## Questions and Responses from the Neighborhood Meeting 3-4-2020

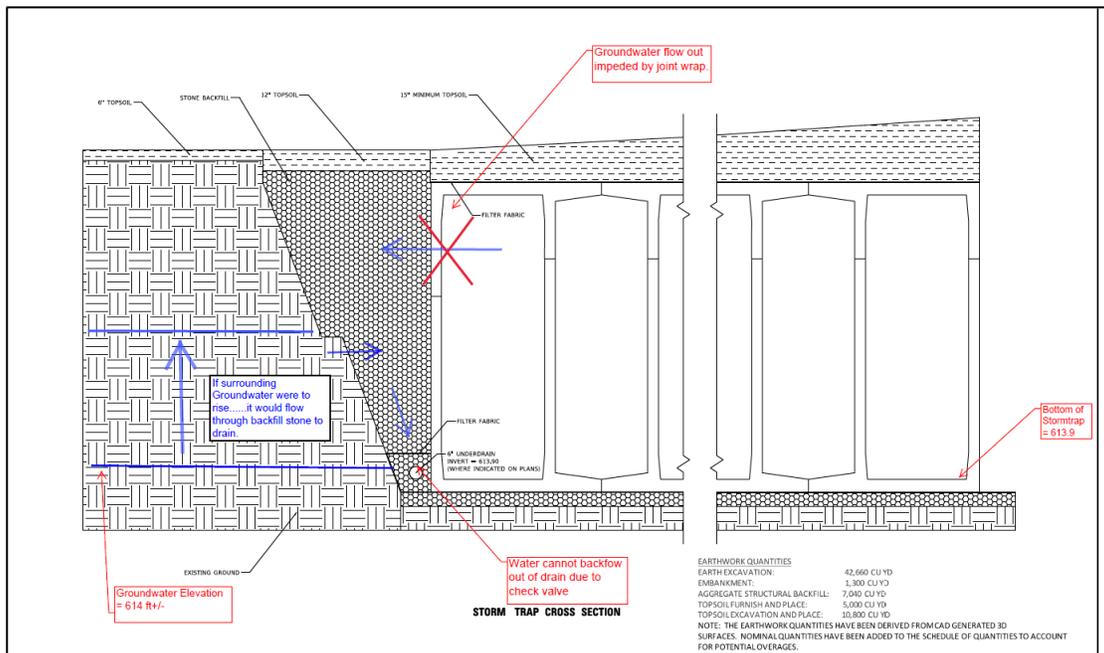
32. What is the water table depth?

*As part of this project, over 50 soil borings and groundwater levels have been collected on the west side of the Village. From this information, we know that groundwater flow from east to west towards the Chicago River. The groundwater elevation at Community Playfield at the time of the soil borings in 2019 was approximately 614 ft. This is 7-9 feet below the ground elevations in Community Playfield, which varies from elevation 623-621 ft.*
